ADDENDUM NO. 2  
TO BID AND CONTRACT DOCUMENTS  
FOR  
Central Weber Sewer Improvement District  
**Dewatering Building HVAC Improvements Project**

**Engineer Project No.: 70123-000**

November 20, 2024

FIGURE A2 - E020 - 001  
ADDITION TO DRAWING E020

**SUPPORT CHANNEL MOUNTED LINEAR FIXTURES  
E-26-0606**

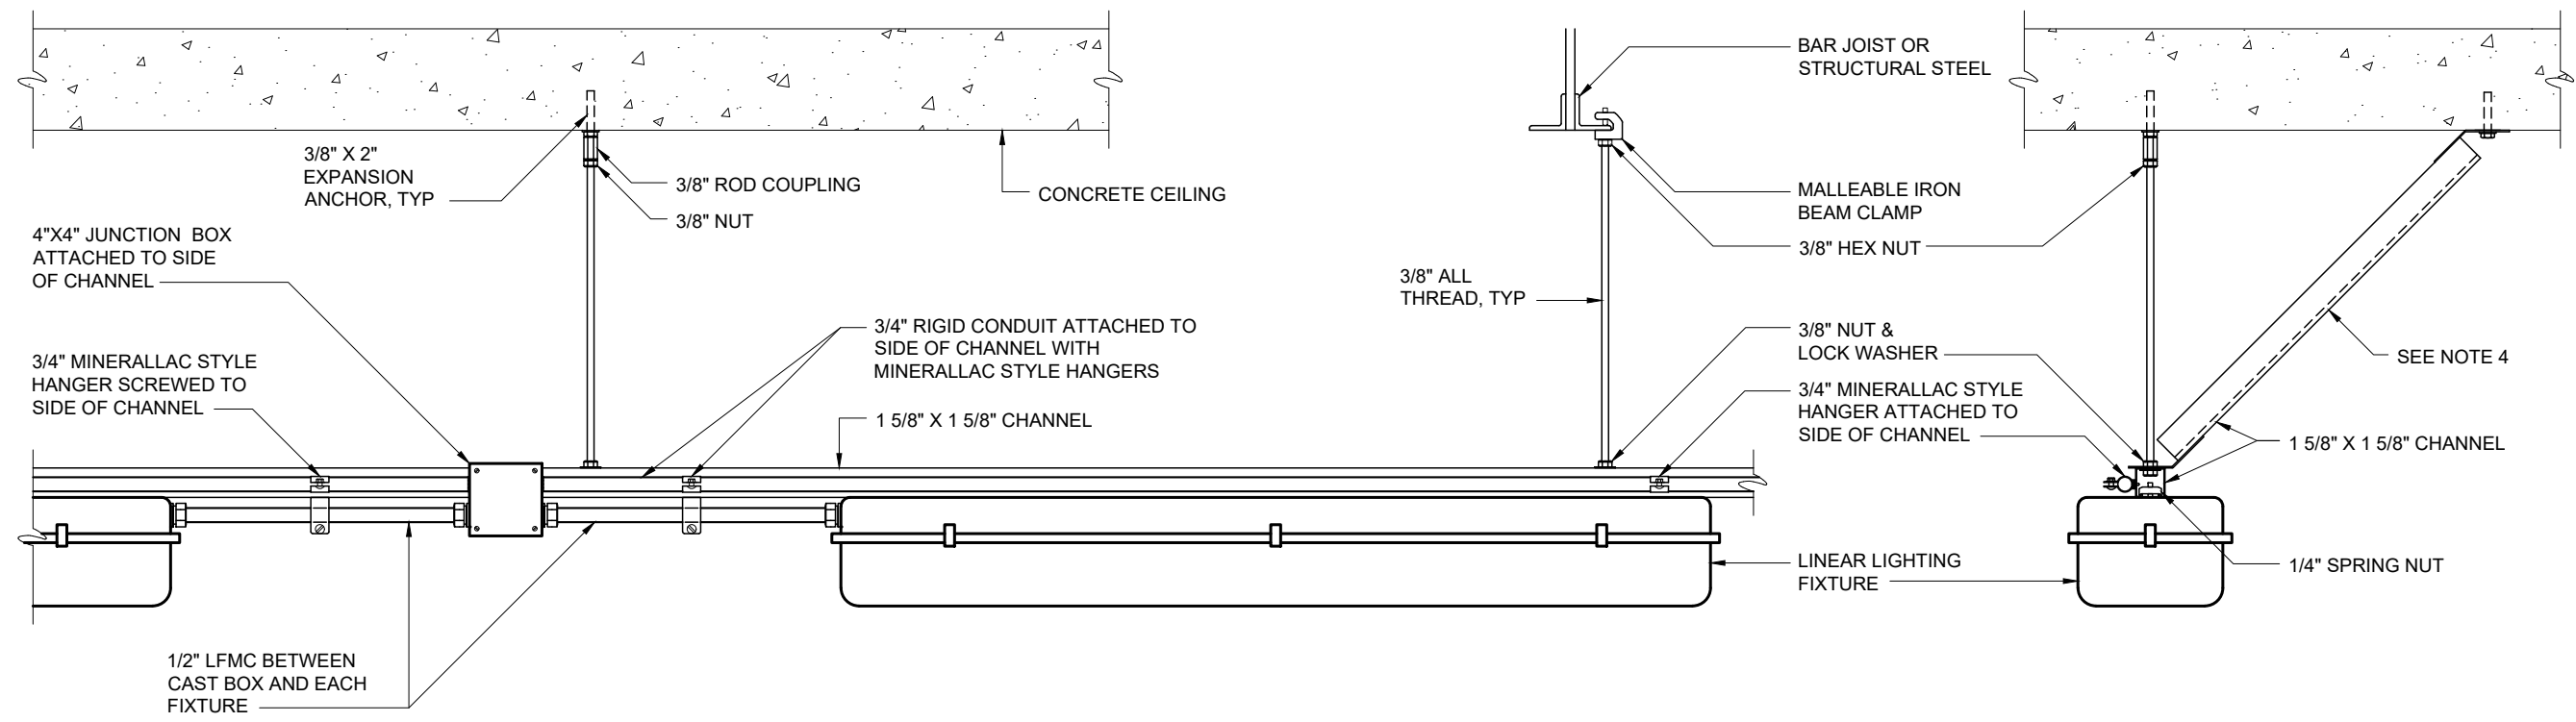
4. Question: During the bid walk it was observed that the existing install has all light fixtures installed with Liquid Tight Flexible Metal Conduit with regular malleable fittings used to connect to light fixtures. Is the Electrical contractor to reuse this in the replacement of all light fixtures with existing supports? Section 260533.13

D. Drawing E020

- i. Add detail E-26-060 in attached FIGURE A2-E020-001 to Drawing E020.

- a. Answer: The intent is for the Electrical Contractor to replace the existing flexible metal conduit to meet the requirements of Section 26 05 33.13 and to replace the existing lighting supports. Refer to detail E-26-0606 added by this addendum for lighting support requirements.

REPLACE EXISTING LIGHT FIXTURES WITH NEW FIXTURES SHOWN. UTILIZE EXISTING POWER AND SWITCHING CIRCUITS FOR NEW FIXTURES. REPLACE EXISTING FLEXIBLE METAL CONDUIT TO MEET REQUIREMENTS OF SECTION 26 05 33.13. REPLACE EXISTING LIGHTING MOUNTING SUPPORTS WITH NEW MEETING THE REQUIREMENTS OF E-26-0606. ADJUST LOCATION OF LIGHT FIXTURES AS REQUIRED TO COORDINATE WITH NEW DUCTWORK.
